OPINION No 04/2024

of 17 September 2024

**on the differences between the national resource adequacy assessment of
Estonia and the 2023 European resource adequacy assessment**

Figure 1. Schematic representation of the modelling approach of ERAA 2023 and the Estonian NRAA

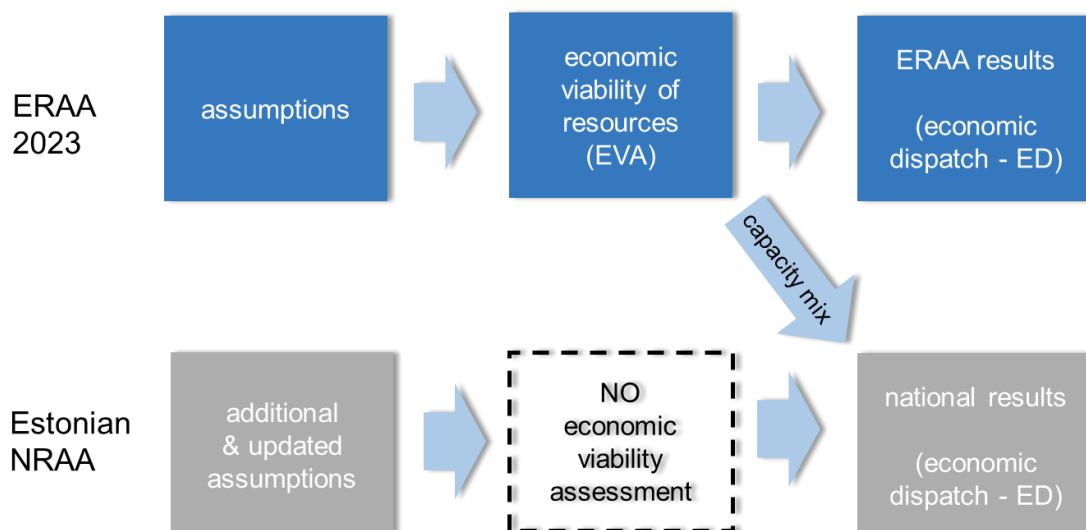
- (14) The Estonian NRAA changes several assumptions but does not assess if those changed assumptions (e.g. less capacity on the market) would trigger investors’ response (e.g.

market entry) which could in turn also affect adequacy results (lower risk). Figure 1 illustrates the modelling approach of the Estonian NRAA and its link with ERAA 2023.
